# DRAFT RESOLUTION

In the matter of the application of:
**MCDOUGALL AMY E. (PLN230127)**
**RESOLUTION NO. 24--**
Resolution by the Monterey County Planning Commission:

[PLN230127, McDougall Amy E., 10196 Oakwood Circle, Carmel, Carmel Valley Master Plan, (APN: 416-542-011-000)]

1 Basement Level -31.0'
1/4" = 1'-0"

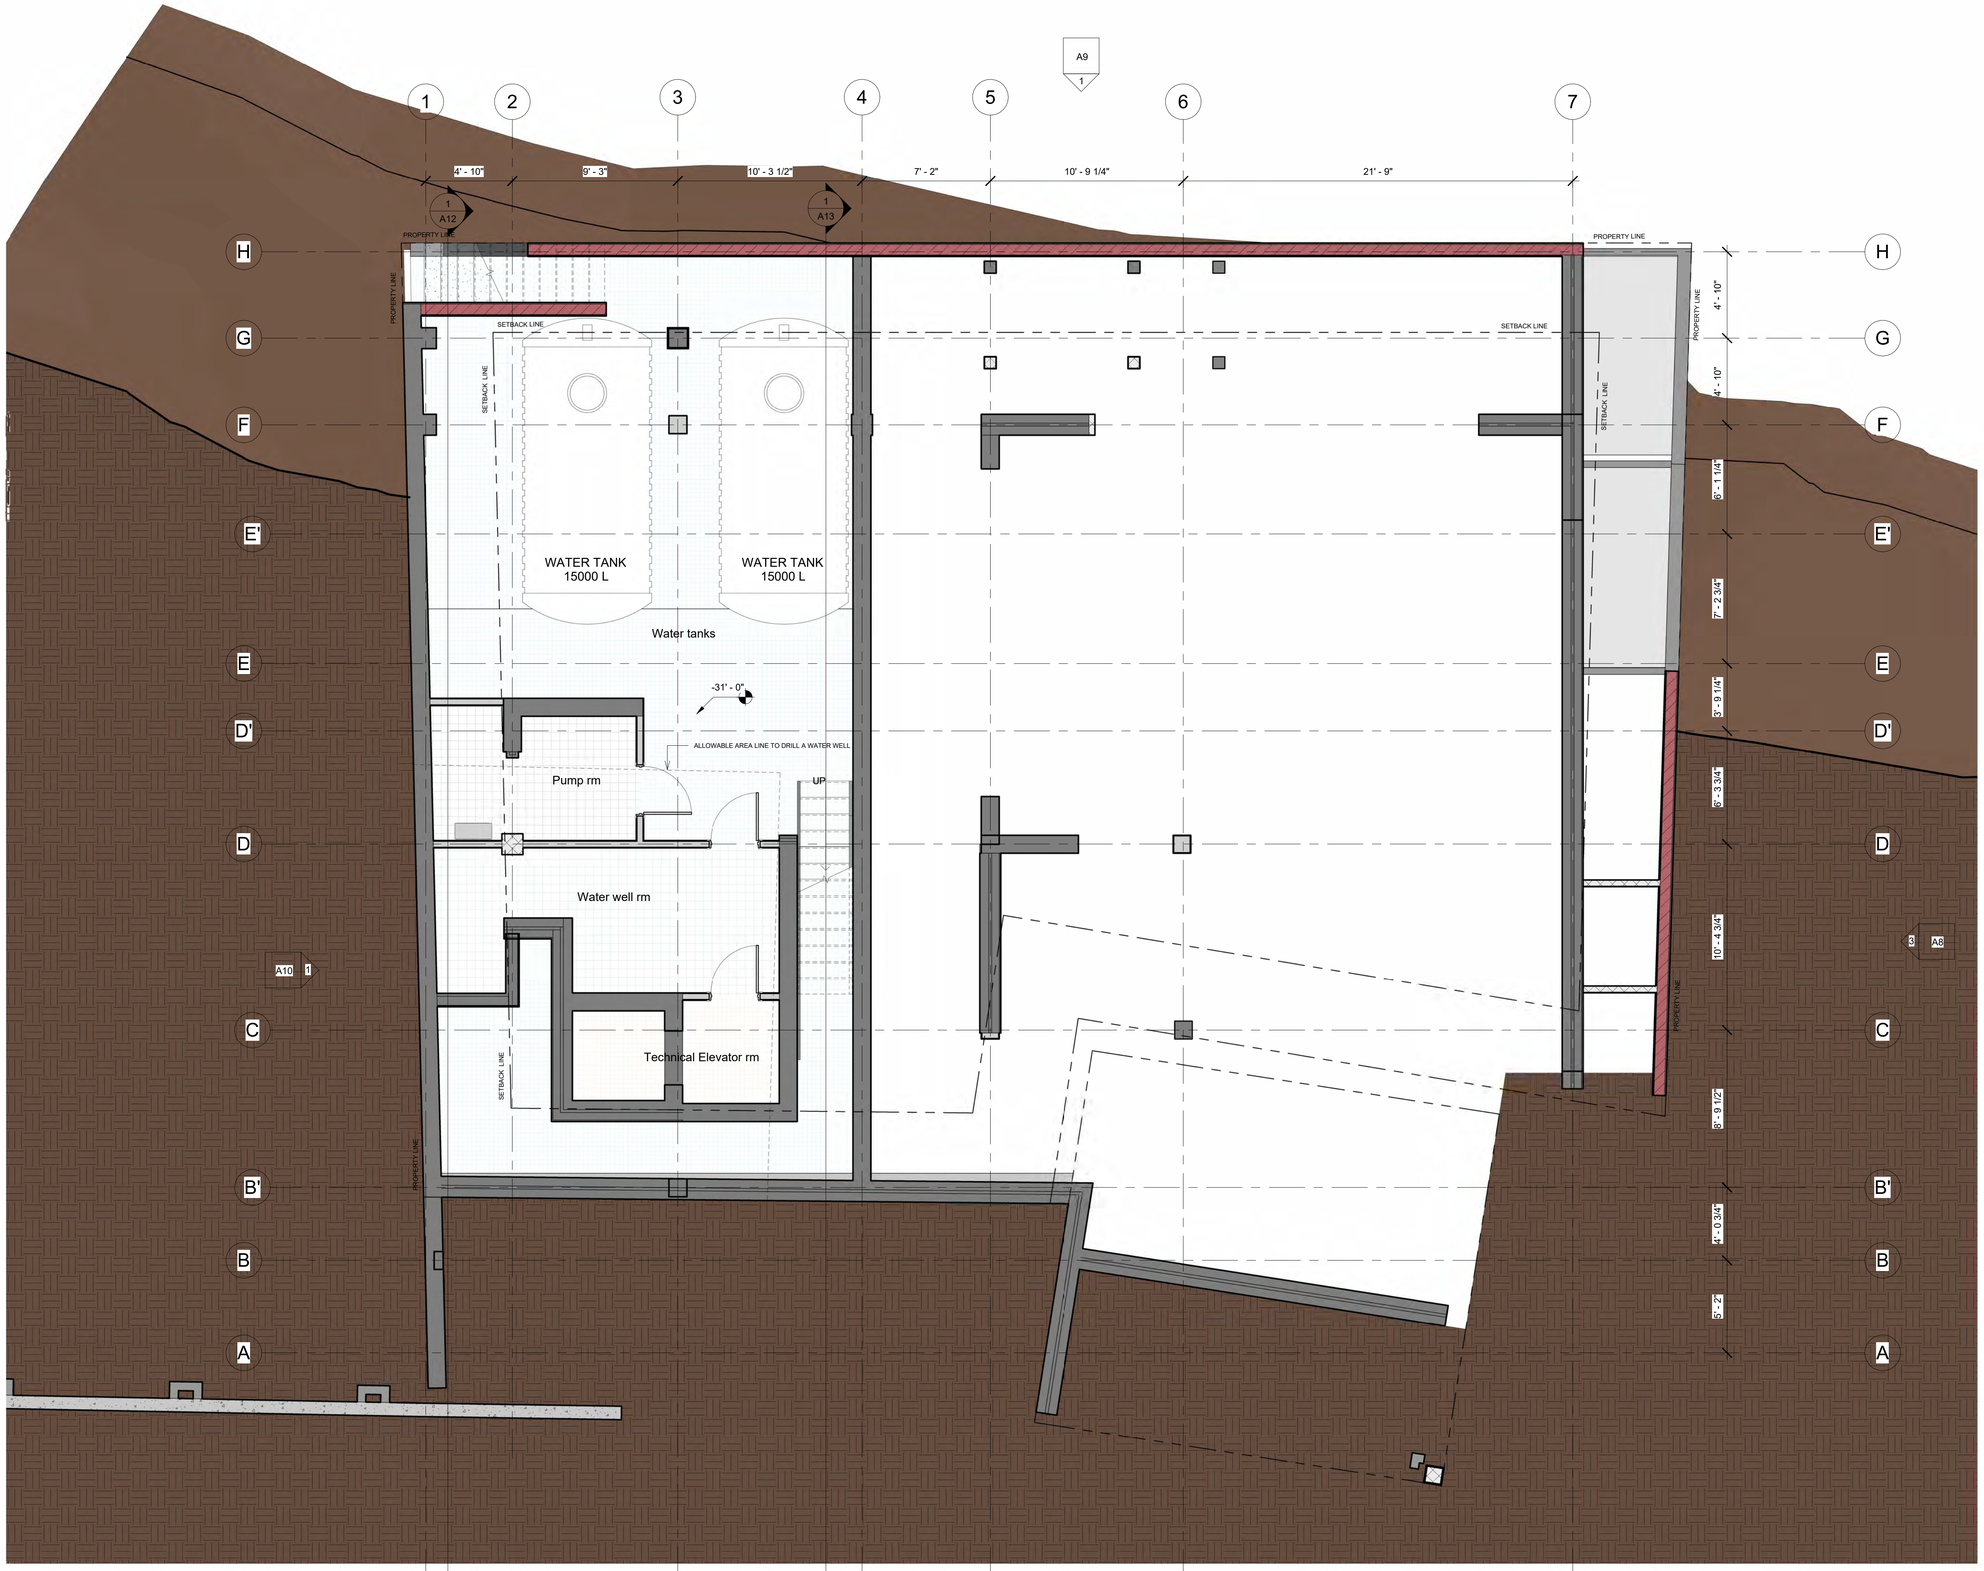
d) Although the proposed ADU has exterior access via a series of staircases, the ADU also has internal circulation with the main residence (see Sheet A5). Additionally, the lower-level basement and well room are only accessible via the ADU. Consequently, the proposed ADU is inconsistent with the requirement that ADUs be independent living quarters that lack internal circulation with the main residence.
